IEEE P802.3dd 10BASE-T1L Droop

8 MARCH 2022

Introduction

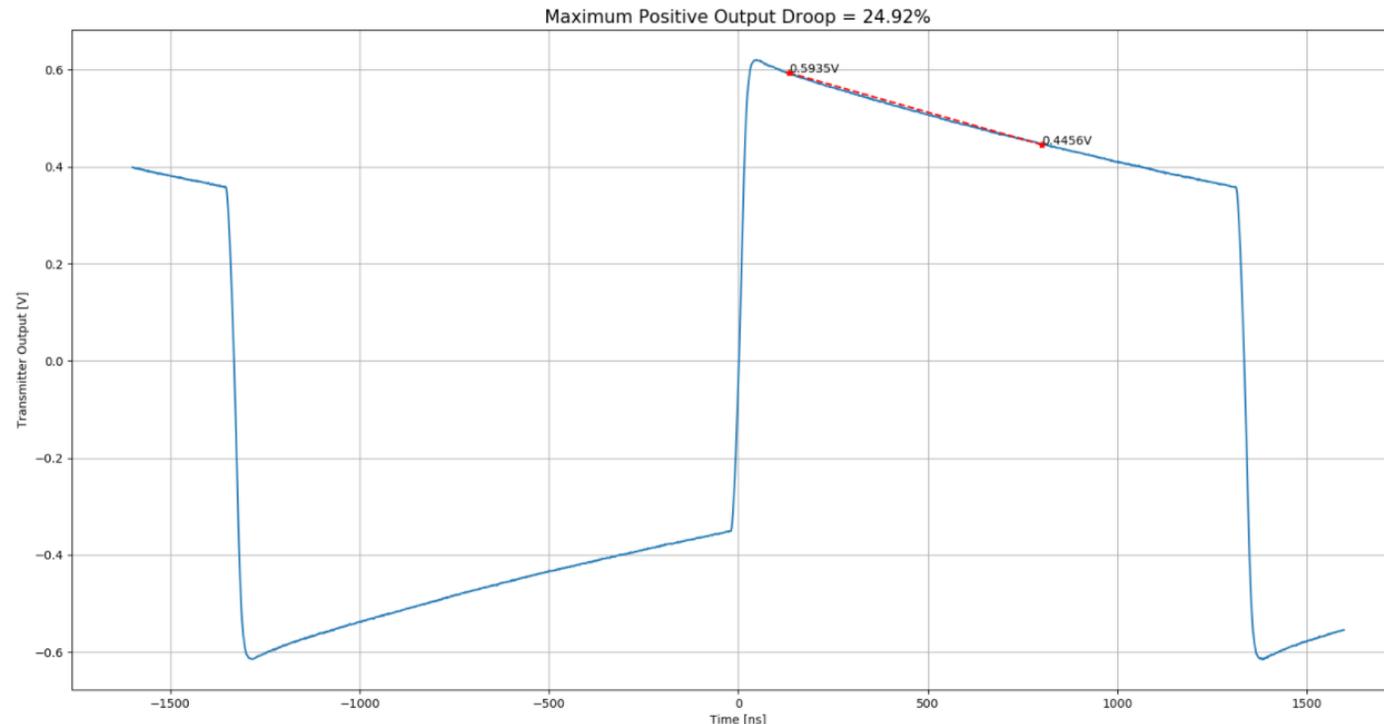
Implementers indicate that receivers are insensitive to droop of 30%, and that it improves economic feasibility for 10BASE-T1L transceivers with inline power.

Change "25%" to "30%" at P26 L24

Droop Computed at Proposed Measurement Points

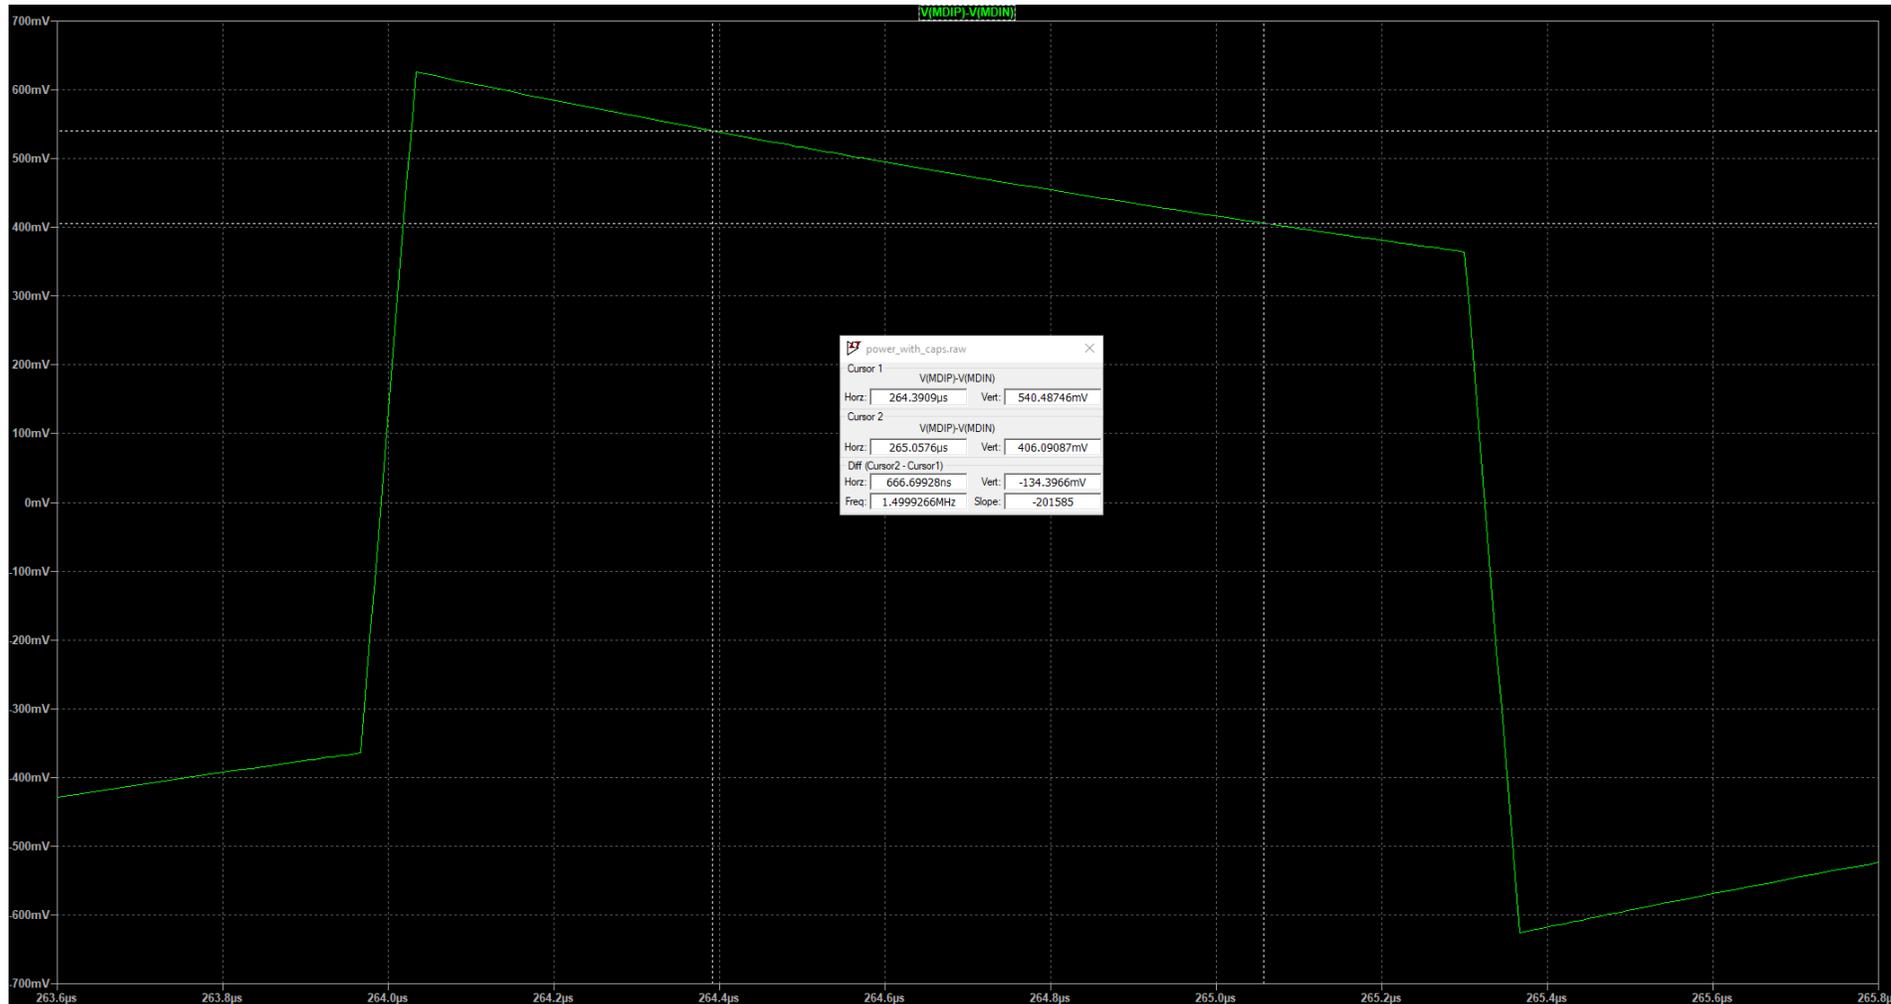
- ▶ With the new measurement points the droop is 24.9% vs 24.4% using the original points from clause 146

Droop Including External PCN

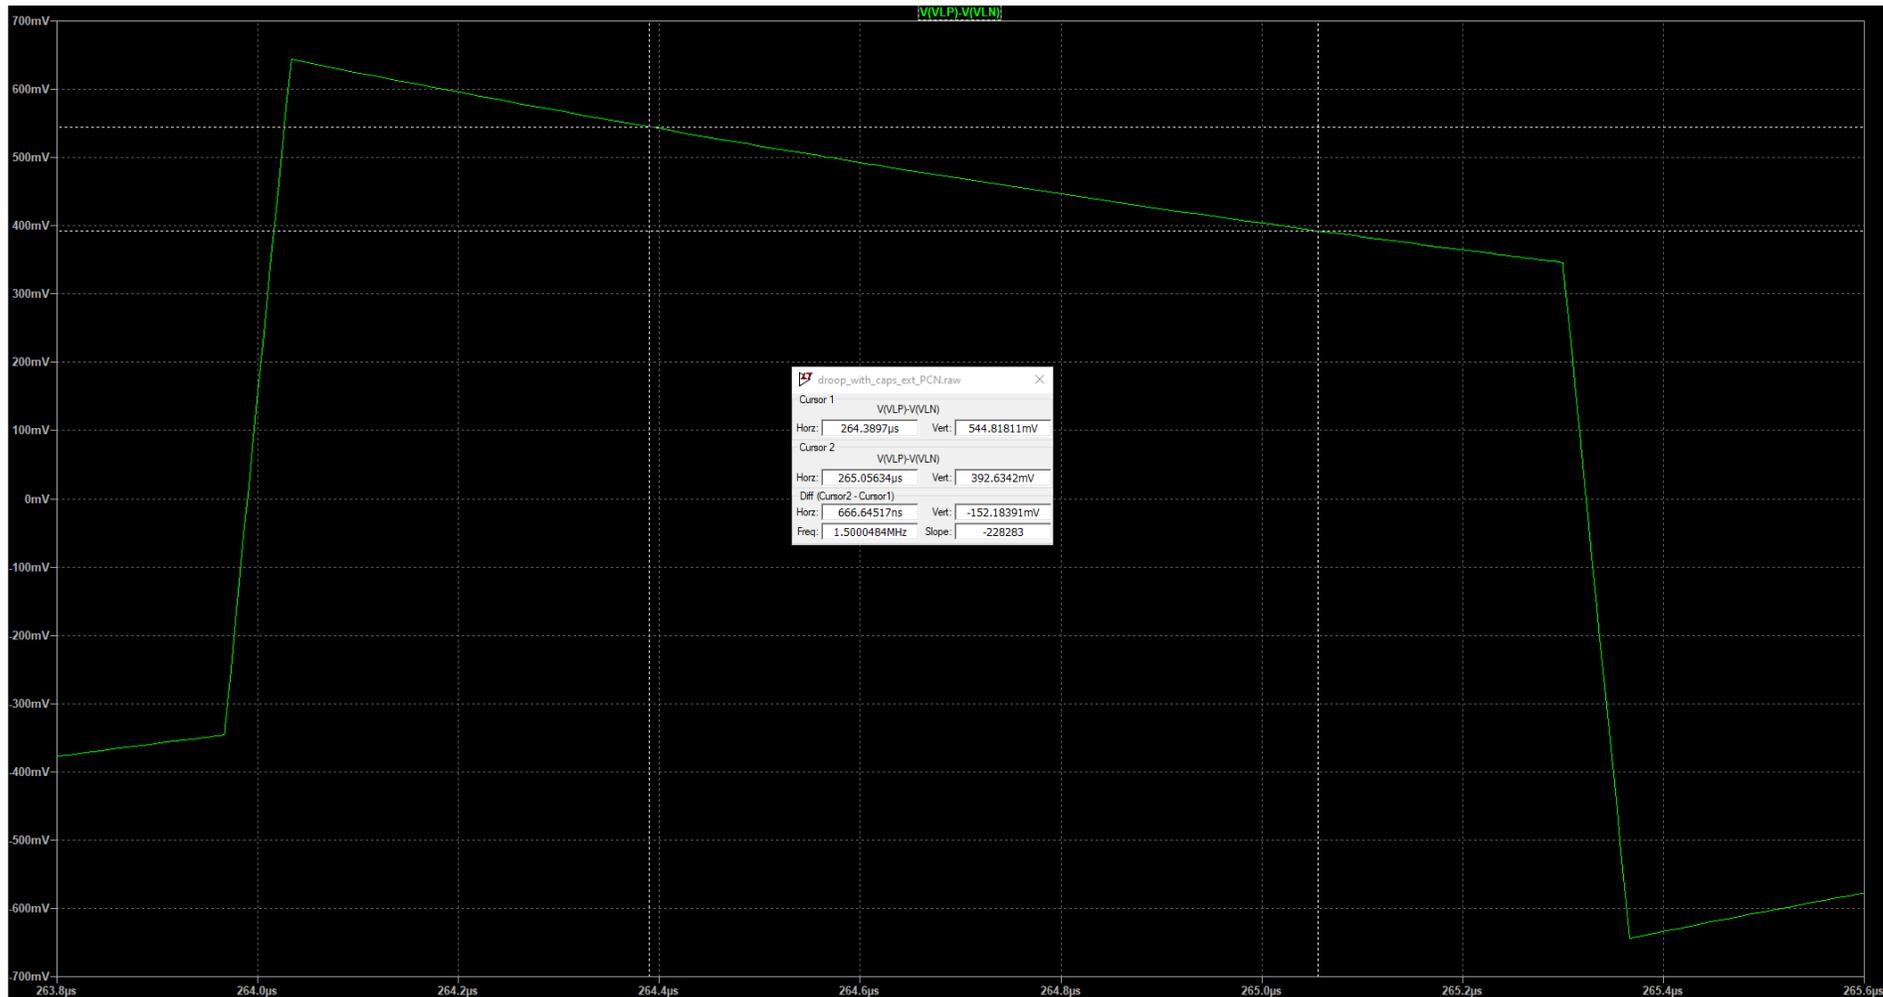
- ▶ In this example the external components required to make the measurement have increased the droop from 24.9% to 27.9%

Effect of Measurement Noise

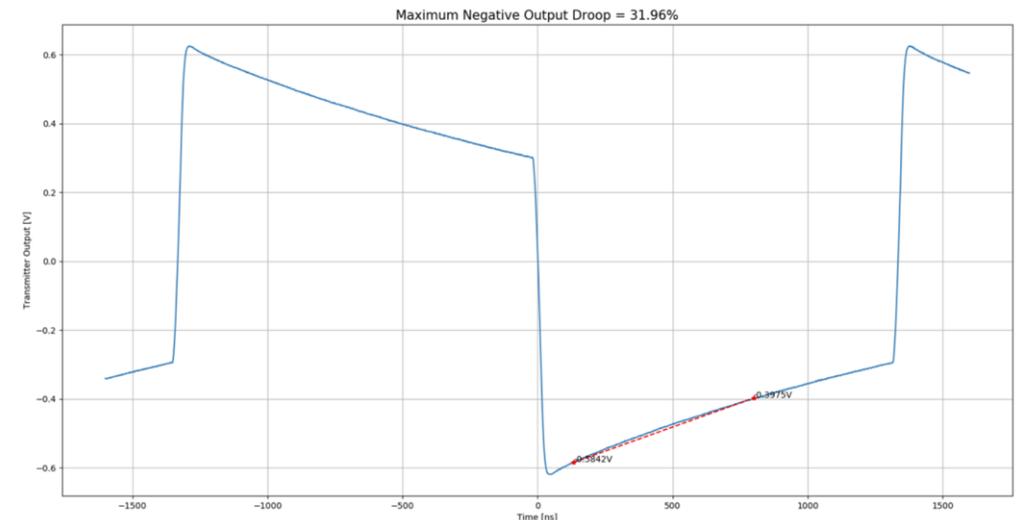
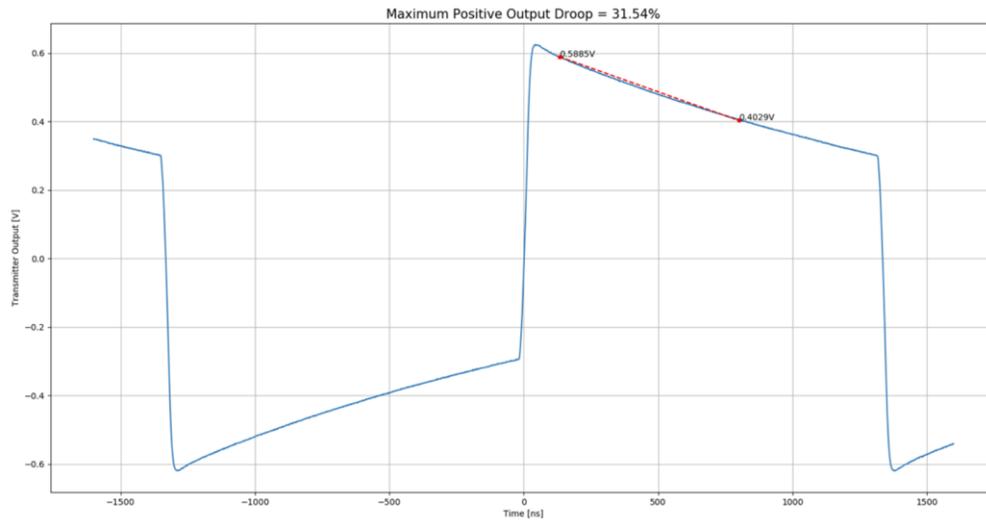
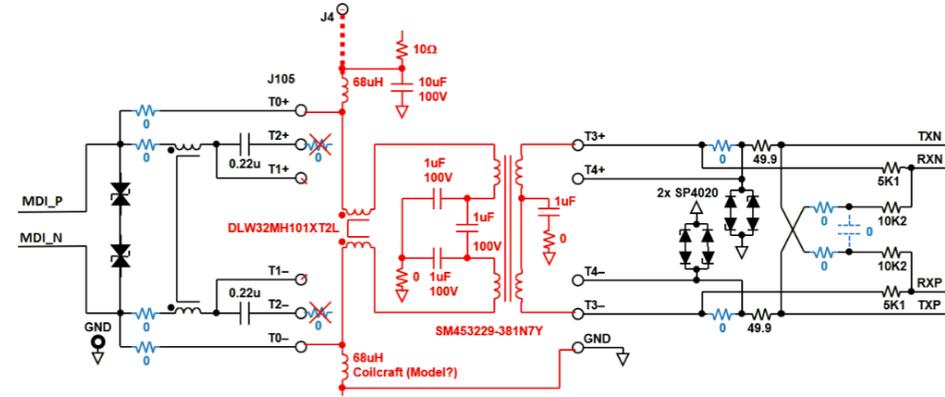
- ▶ Common approach is to measure droop multiple times and take the worst value
 - Droop measurement is therefore affected by the peak-to-peak noise in the system
 - Most of this noise is expected to be in the measurement itself
- ▶ Consider 10mV peak-to-peak noise
 - In our last example the values 544.8mV and 392.6mV would become 549.8mV and 387.6mV giving droop of 29.5%
 - A PHY having droop of less than 25% would give a measured droop of close to 30%

Measured PHY Performance for Return Loss

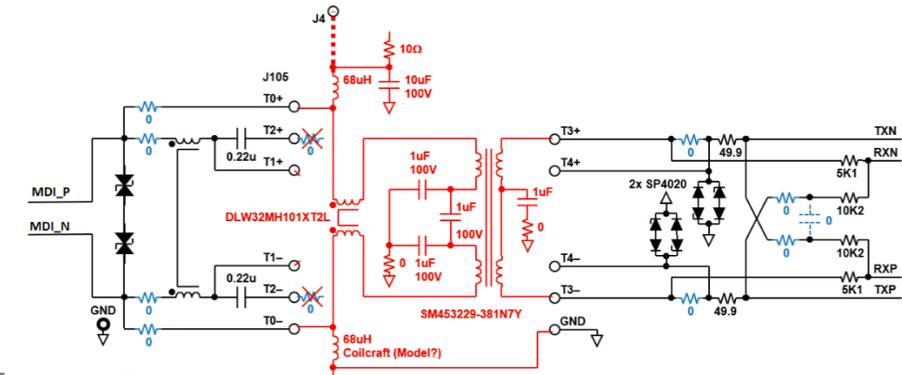
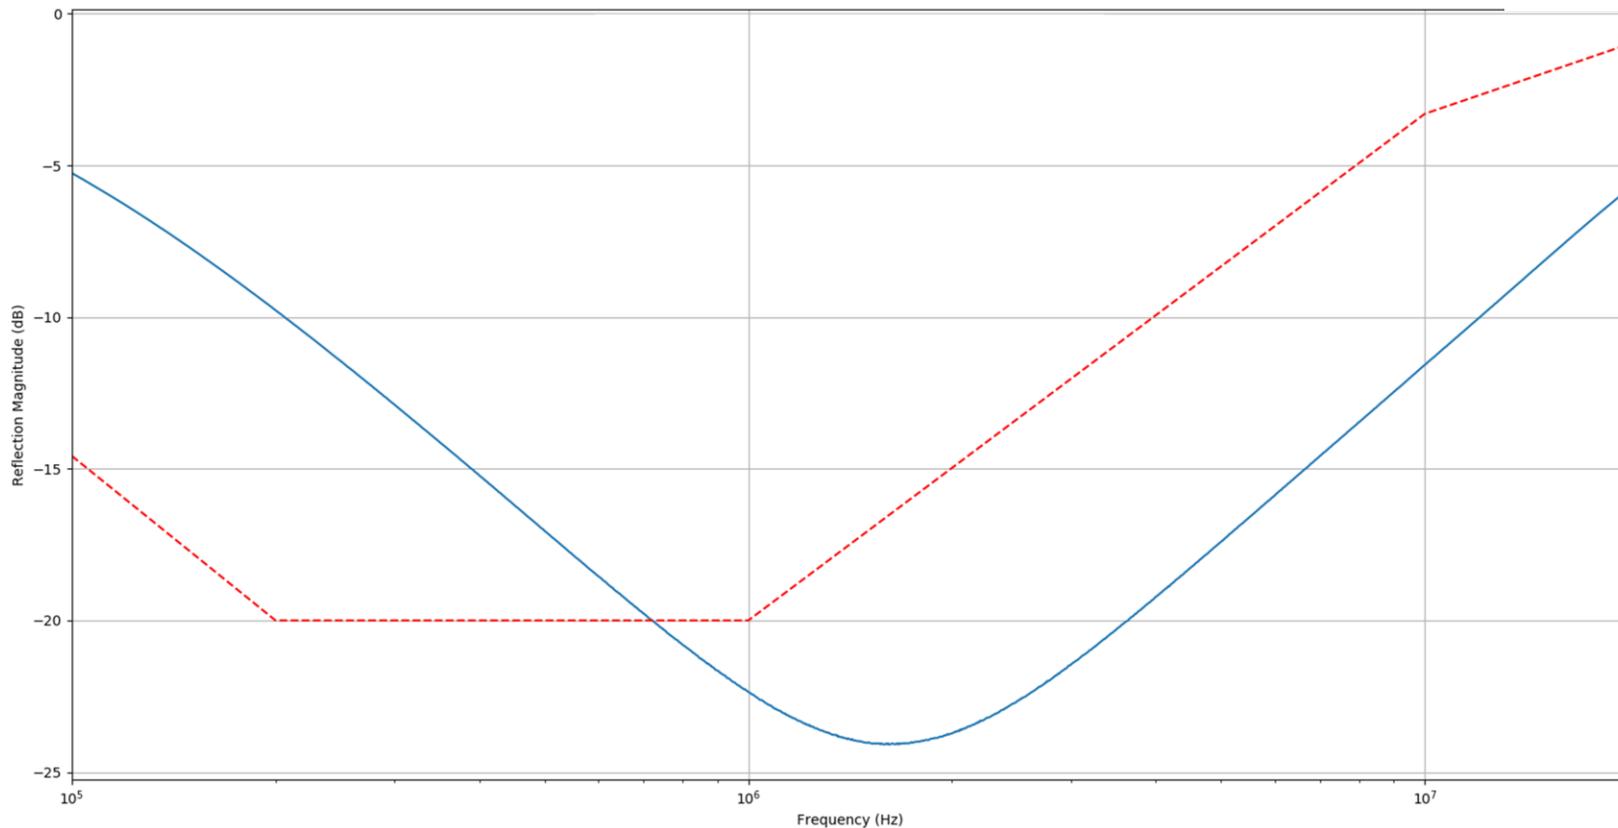
- ▶ Return Loss is measured on this circuit and it is shown that it fails the return loss limit
 - Crossing the -20db beyond 500kHz
 - This is expected as the droop is > 25%
